**Planning & Zoning Commission  
Agenda  
Wednesday, September 2, 2020, 7:00 p.m.  
Via Zoom Virtual Meeting  
Posted August 26, 2020**

- 1. PZ-28-20 ZONING CODE AMENDMENT, SPECIAL USE PERMIT (ASSISTED LIVING), AND SITE PLAN REVIEW FOR MIXED-USE DEVELOPMENT IN B-2 ZONING DISTRICT 300 NORTH KIRKWOOD ROAD**  
Submitted: 2-21-20; Revised 8-26-20 Automatic Recommendation: 9-24-20  
Petitioner's Agent, George Stock  
(Subcommittee – Commissioners Adkins, Diel, and O'Donnell)  
*Opportunity for Public Comment*

Please see below for Opus Development Company's response to comments received by Kirkwood City Staff on July 30<sup>th</sup> 2020 and Planning & Zoning Subcommittee on August 4<sup>th</sup> & 21<sup>st</sup> 2020.

**CITY OF KIRKWOOD  
PLANNING AND ZONING COMMISSION  
SUBCOMMITTEE REPORT  
September 2, 2020**

**SHEET NO.:**  
 C-1

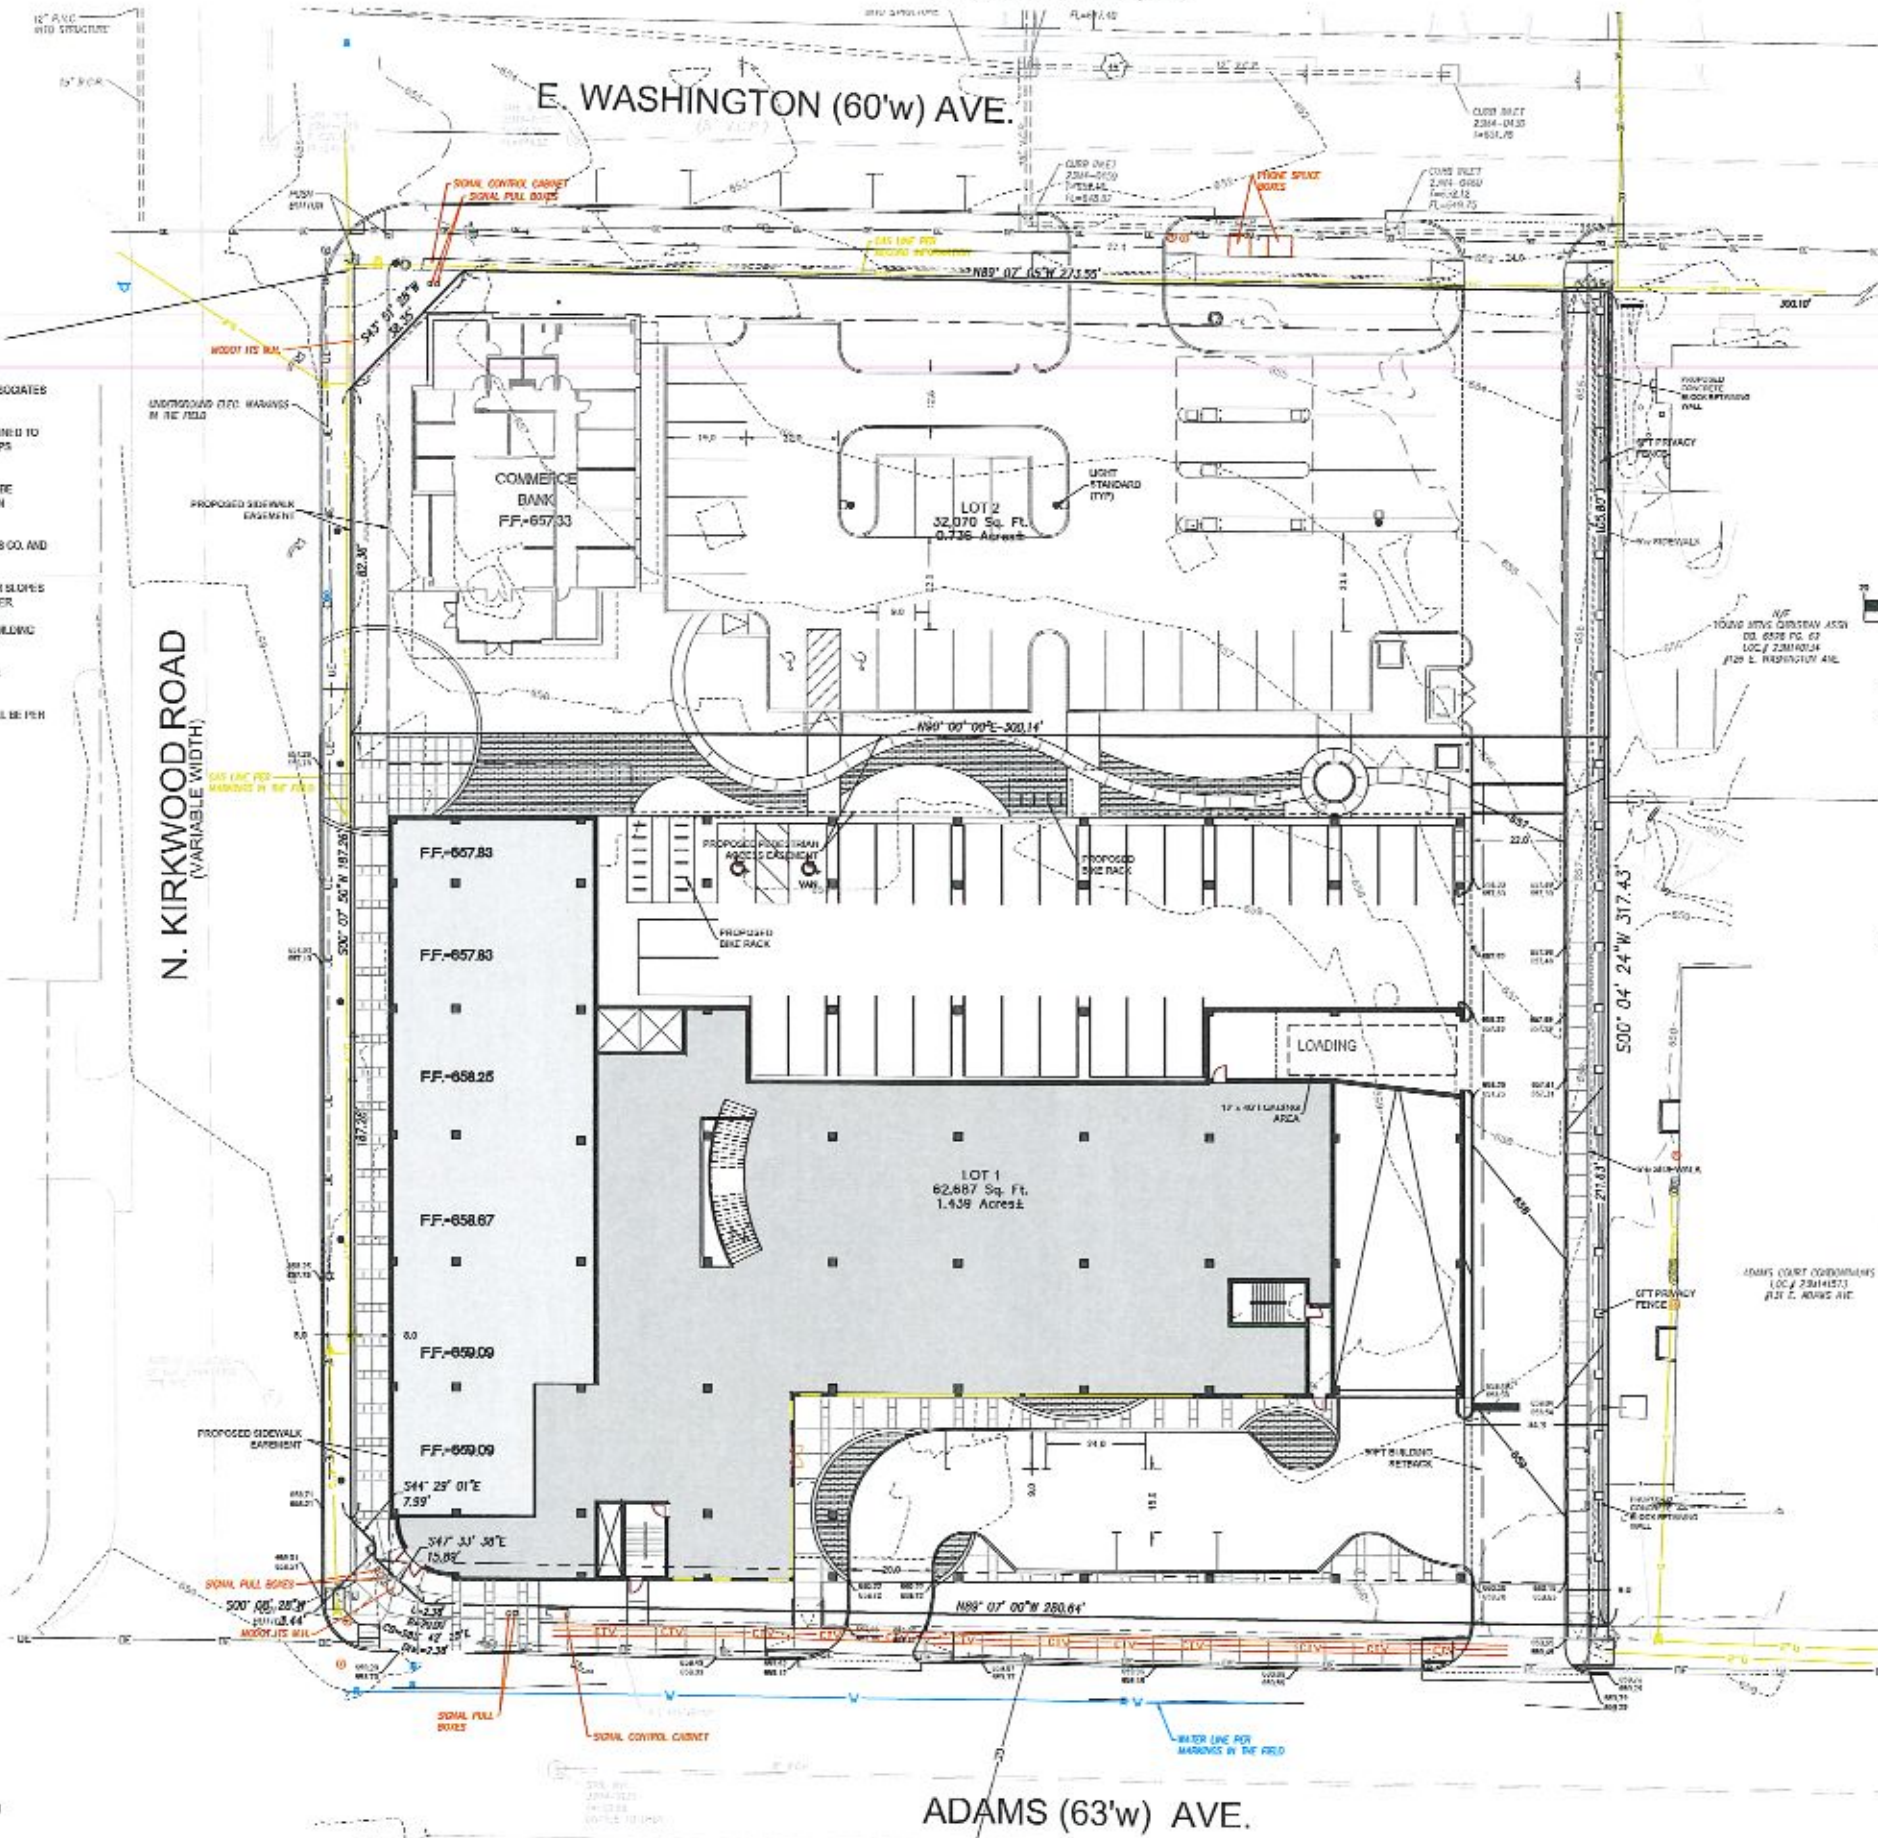
2. Revise ADA van spaces per Kirkwood's parking regulations.

4. Revise sidewalk and planting areas along Kirkwood Road to be 8' each.

5. Add sidewalk along the Eastern boundary to connect E. Washington Ave. and E. Adams Ave.

- **Response: The Level 1 A.D.A. spaces are now designed to be 9' wide x 19' long. Note that this dimensional change resulted in the Retail Area Parking Stall count to drop from 31 to 30. For the Lower Level Parking, the A.D.A. spaces are now designed to be 9' wide x 19' long. See revised Architectural Site Plan and Lower Level Parking Plans dated 8-14-2020 enclosed. We meet the requirement.**

- **Response: Requested revisions were made and included on the enclosed plans.**

- **Response: A 5' wide sidewalk has been added along the Eastern boundary. This will result in a reduction in the size of the planting area. There will still be room for smaller plantings and the 6' sight proof fence. This sidewalk will also be connected to the Linear Park via a pedestrian friendly crossing. Revisions were made and included on the enclosed plans.**

SHEET TITLE:  
**SITE**  
**PHOTOMETRIC**  
**PLAN**  
 SHEET NO.:  
**LT-1**

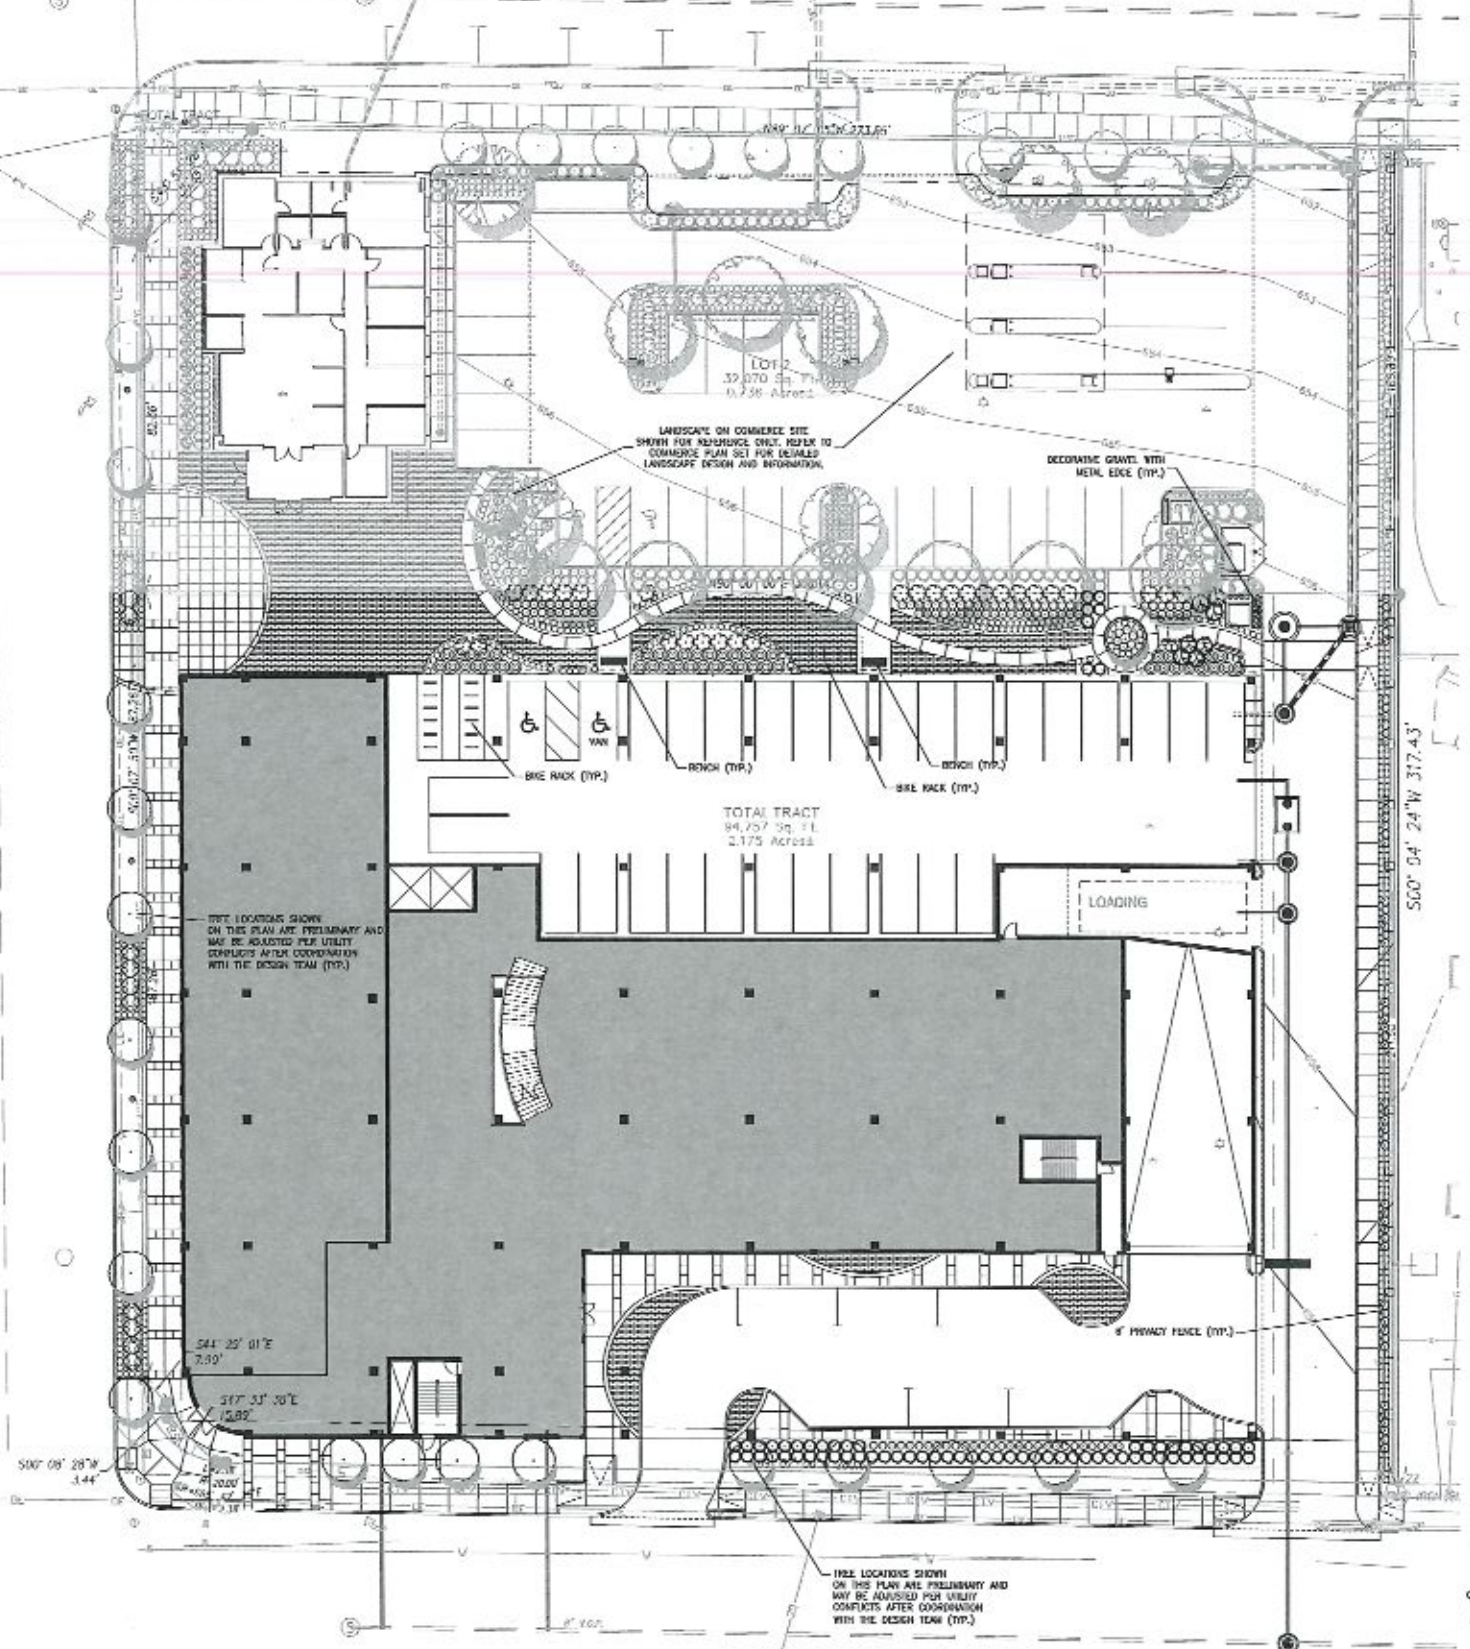
8. Prior to City Council approval, a revised lighting plan shall be submitted which provides adequate lighting levels for the proposed sidewalk along the eastern property line.
